UNITED STATES PATENT AND TRADEMARK OFFICE

APPLICATION NO.	FILING DATE	FIRST NAMED INVENTOR	ATTORNEY DOCKET NO.	CONFIRMATION NO.
10/500,904	02/11/2005	Philippe Vincent	12400-015	1396
757 7590 07/20/2007 BRINKS HOFER GILSON & LIONE P.O. BOX 10395 CHICAGO, IL 60610			EXAMINER CULBRETH, ERIC D	
			ART UNIT 3616	PAPER NUMBER
			MAIL DATE 07/20/2007	DELIVERY MODE PAPER

Office Action Summary	Application No. 10/500,904	Applicant(s) VINCENT ET AL.	
	Examiner Eric Culbreth	Art Unit 3616

DETAILED ACTION

FIG. 2

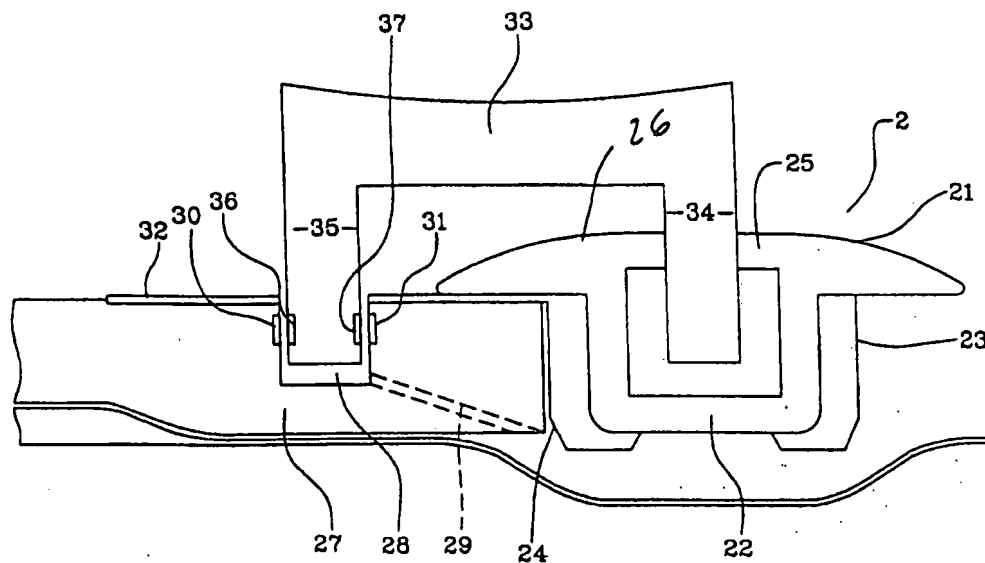
a. Regarding Figure 2, the lead line for reference numeral 2 should touch the track or have an arrow (note paragraph [0037]).

b. Contrary to paragraph [0037], line 4 the lead line for reference numeral 26 in the replacement drawing does not touch an inwardly directed lip.

d. Regarding paragraph [0045], next to last line, reference numeral 62's lead line does not touch the squib.

FIG. 3

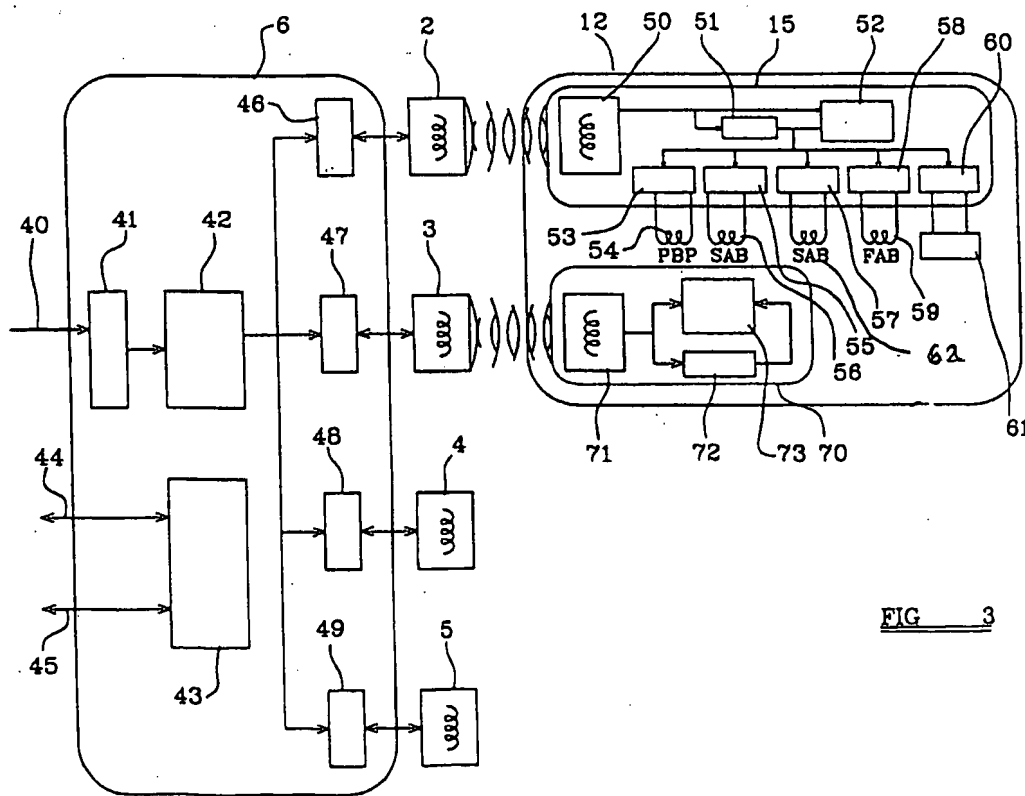
c. Regarding paragraph [0043], lines 4-5 controller 42 is not illustrated as connected to inter-face 43 in Figure 3.
